ADDRESSEES	: All owners and operators of vehicles with Fuel Pro filter ABC Customer Care and Parts Source
VEHICLE MODEL	: All
MANUAL CHAPTER	: 2.30 Traction engine – Fuel system
BULLETIN TYPE	: Service information
DATE	: September 03rd, 2026
SUBJECT	: Installation instructions for Fuel Pro filter element
CONDITIONS	: This service bulletin does not entitle to any reimbursement.

FUEL PRO FILTER ELEMENT INSTALLATION INSTRUCTIONS (MODIFIED)

Figure 1: Fuel Pro fuel filter, exploded view

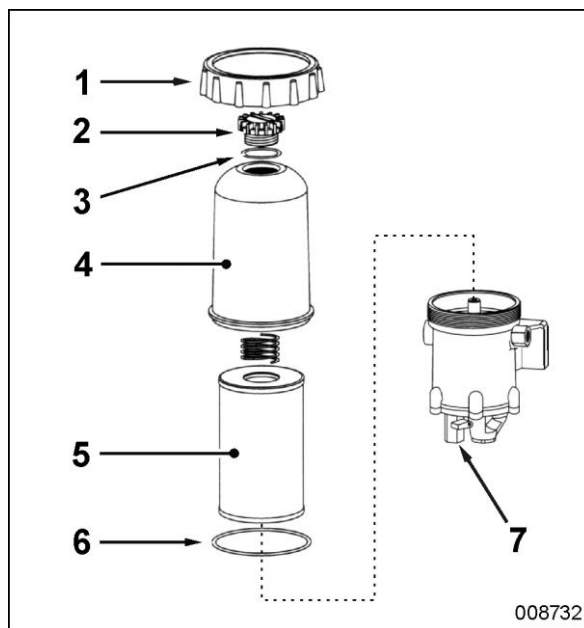
This service bulletin has been released to inform you about a change in the installation instructions for the Fuel Pro filter element, which can be found in the maintenance manual of your vehicle. The securing ring of the transparent bowl must be **tightened to a torque of 24 Nm (18 ft.lbf)** instead of hand-tightened.

Step	Action
1	Install a new O-ring (6).
2	With a light twist, push new element (5) onto its seat.

3	Install transparent bowl (4) and tighten securing ring (1) by hand.
4	By means of tool Fleetguard 3944451 S (plastic) or Fleetguard 3944448 S (metal), finally tighten securing ring (1) to a torque of 24 Nm (18 ft.lbf).  Figure 2: Fleetguard tool for Fuel Pro filter
5	Remove vent plug (2).
6	Fill transparent bowl (4) up to halfway with clean fuel.
7	Install vent plug (2) with a new sealing ring and tighten it by hand.
